Response to Additional Information
Requests
DA 21/11288

Perisher Views Ski Lodge
Lot 1, DP1192372
Burramys Road, Perisher Valley

Geoanalysis Pty Ltd
June 2022

Below: Borst & Co 3D photomontage (photo courtesy KAL)

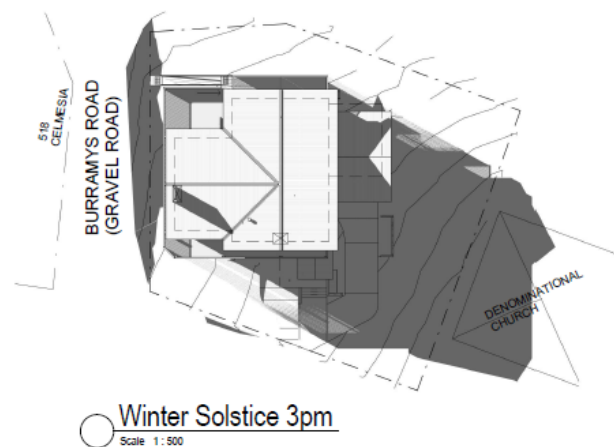
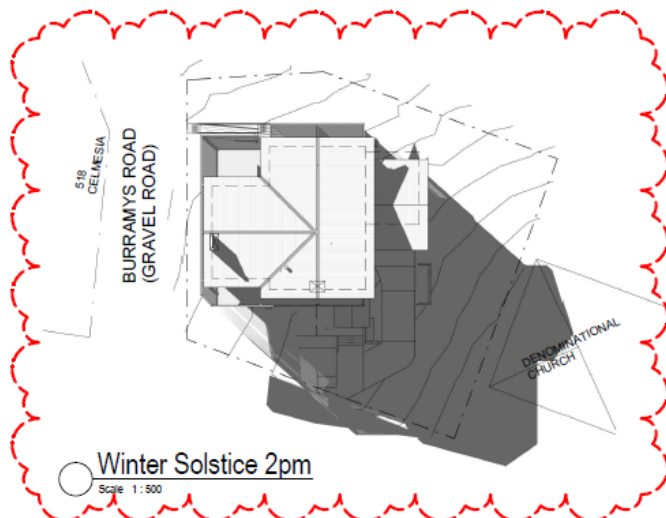
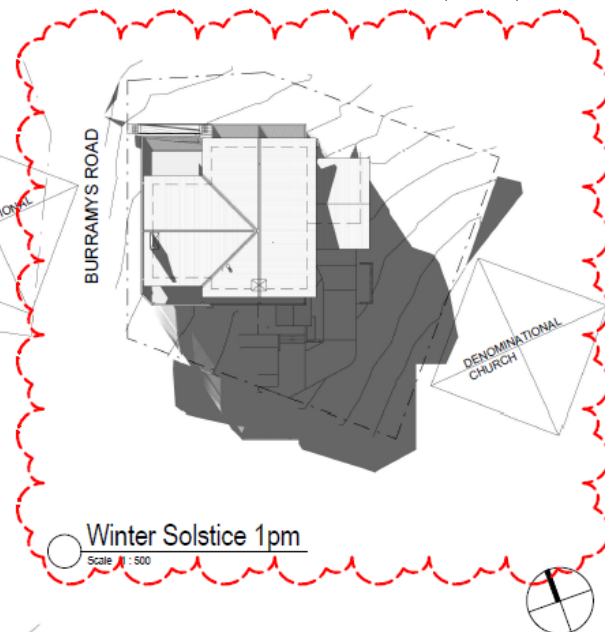
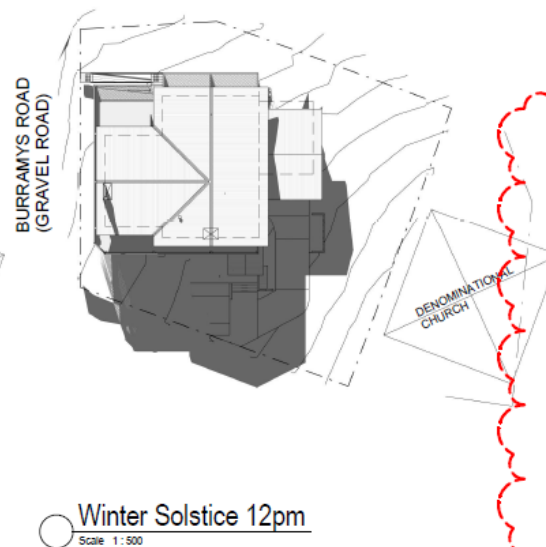
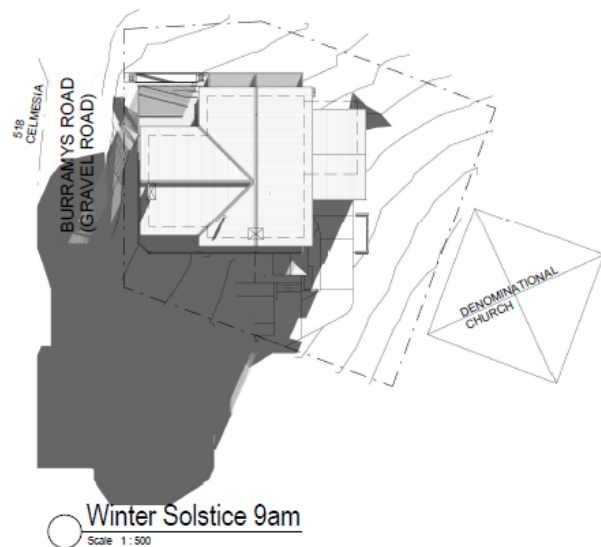
- **Inclusion of additional visual analysis from adjoining properties – photomontage of the building into the existing landscape when viewed from Ku-ring-gai and the Perisher Centre / Hotel.**

The following page compares the photo provided in the KAL submission with a 3D montage of the proposed development prepared by architects Borst and Co. The KAL submission shows the building extending to the telegraph pole and being well above the height of Burramys Road. Whereas the plans below show the closest eave and wall being located approximately 8.8m and 10m respectively southeast of the telegraph pole. The architects photomontages demonstrates that the proposed building is barely visible from KAL.

Photomontages have been prepared by Borst and Co Architects and are included in the architectural drawing plans. These images demonstrate that there will be minimal impacts on ku-ring-gai lodge and the building form is consistent in scale and architecture to existing structures.

The RL of the top floor level is 1743.50, this is 10mm below Burramys Road where the concrete stormwater pipe is located, whereas the KAL submissions shows the building being well above Burramys Road at this location.

Significant effort has been put into minimising impacts on the views to KAL including recessing the north-western corner of the building, whilst also maximising the setbacks from the Alpine Church. As shown on the following page the proposed lodge will not impact on the views to Mount Perisher from KALs kitchen window, is located behind tree and will be barely visible.

Scale: 1:500
 DA_11A

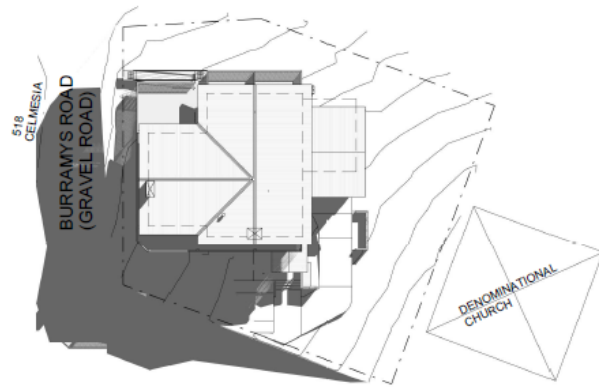
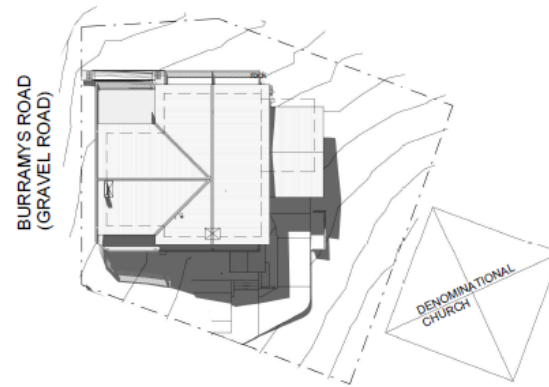
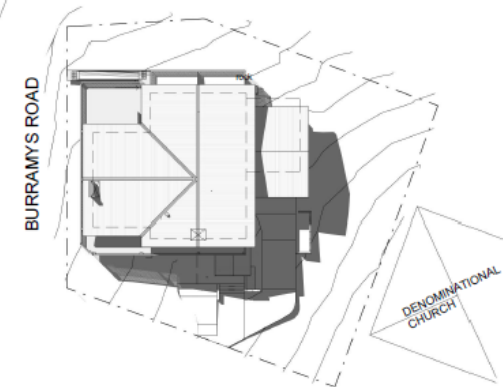
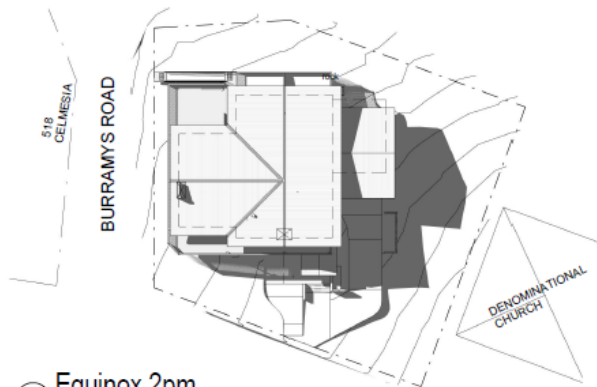
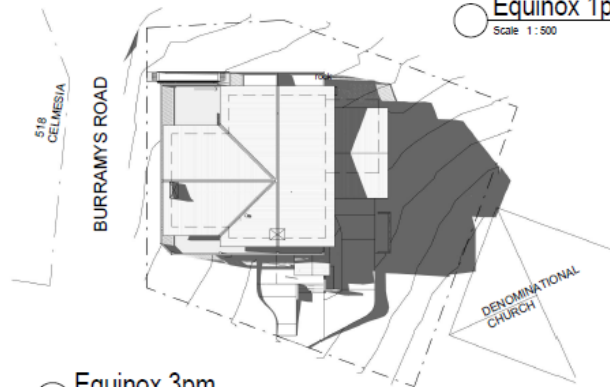
- **Solar access diagrams indicating 1pm and 2pm shadows from the building. In addition, submission of September 21 shadows from the building for the Department to consider impacts upon the adjoining Alpine Church.**

These have been prepared and are included in the updated architectural drawings.

The winter solstice occurs early in the season (typically around the 22nd June) and overshadowing of the church commences at approximately 1pm, occurring later in the day each day thereafter. Church services occur from 12.30 to 1pm every Sunday. The spring equinox occurs later in the season (around 22nd September) and overshadowing at this later stage of the season starts after 3pm (shadow diagrams are provided on the following pages). Three (3) hours of sun on the solstice is a common planning standard in NSW, with the sun rising before 8am on the solstice the church would receive in excess of 5 hours of sun.
